Reading West Station NMA

Application Reference 210938/NMA

Original Reference 201448

Outline of Proposed Elevational Changes

East Elevation: Extract from the approved drawing 2000

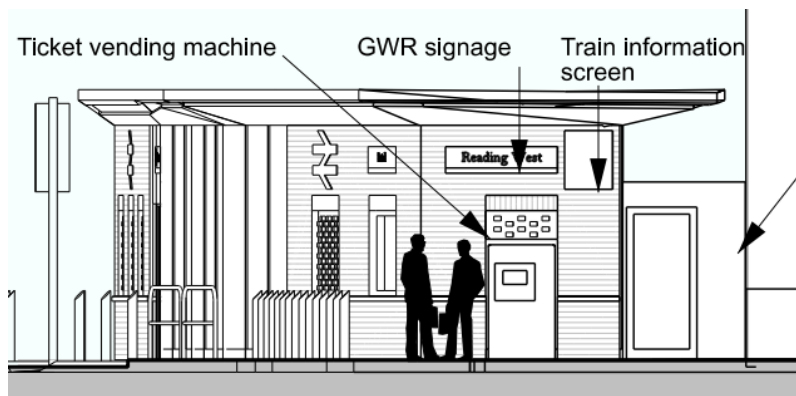
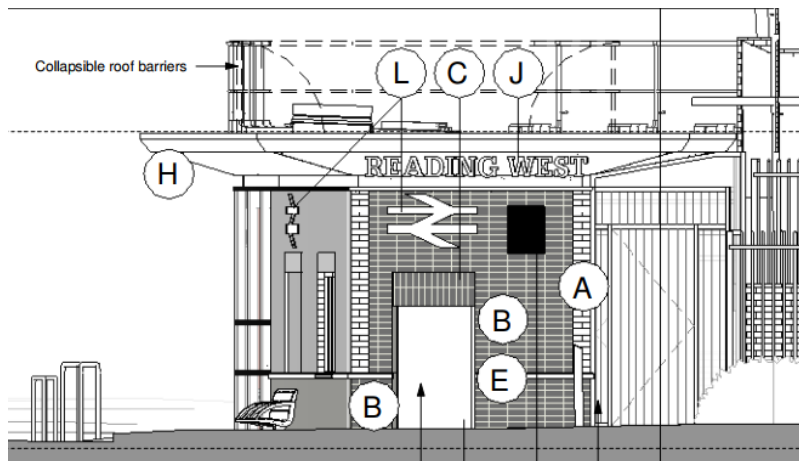
Minor amendment of the east and west elevations to increase the area of darker plinth bricks all the way to the roof line to better emphasise the street elevation viewed from along Oxford Road. This was guided by the Design Review Panel who felt a stronger emphasis was required to these key views of the station building. The signage has been similarly adapted to make it clear that this is a station building and a point of arrival.

Note: the roof handrails will be folded flat against the roof when not in use for maintenance.

Summary of Proposed Internal Changes

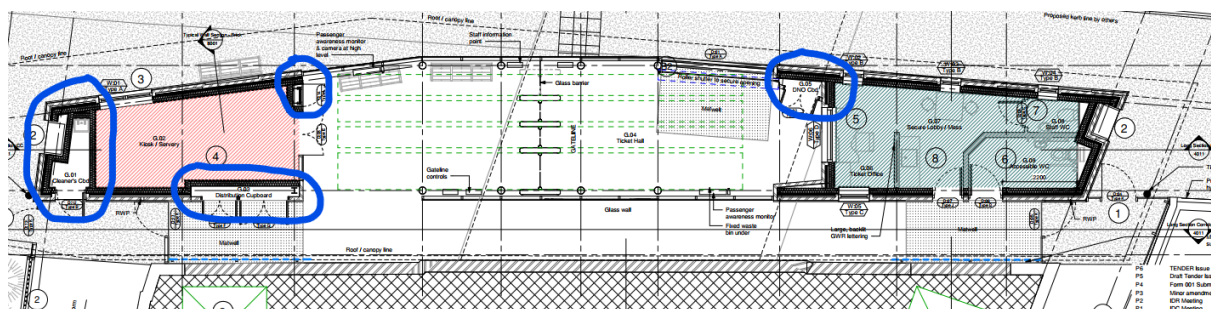
These are to facilitate the servicing and maintenance of the building

- Cleaner's cupboard added on west end of the building
- Services cupboards added adjacent to the retail unit and ticket desk
- Roof access ladder added on the west wall of the ticket hall

Summary of Proposed Changes to the Roof plan

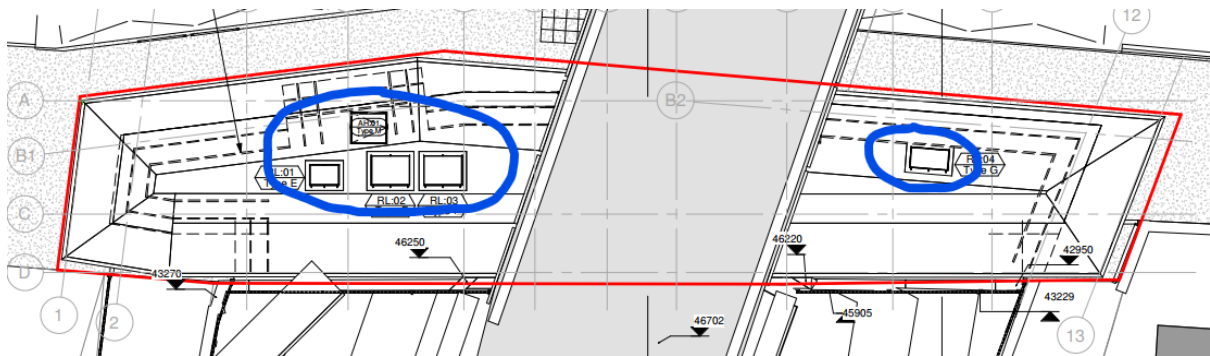
- Addition of 4 number rooflights for increased natural light inside the building
- 1 Roof access hatch to facilitate roof maintenance
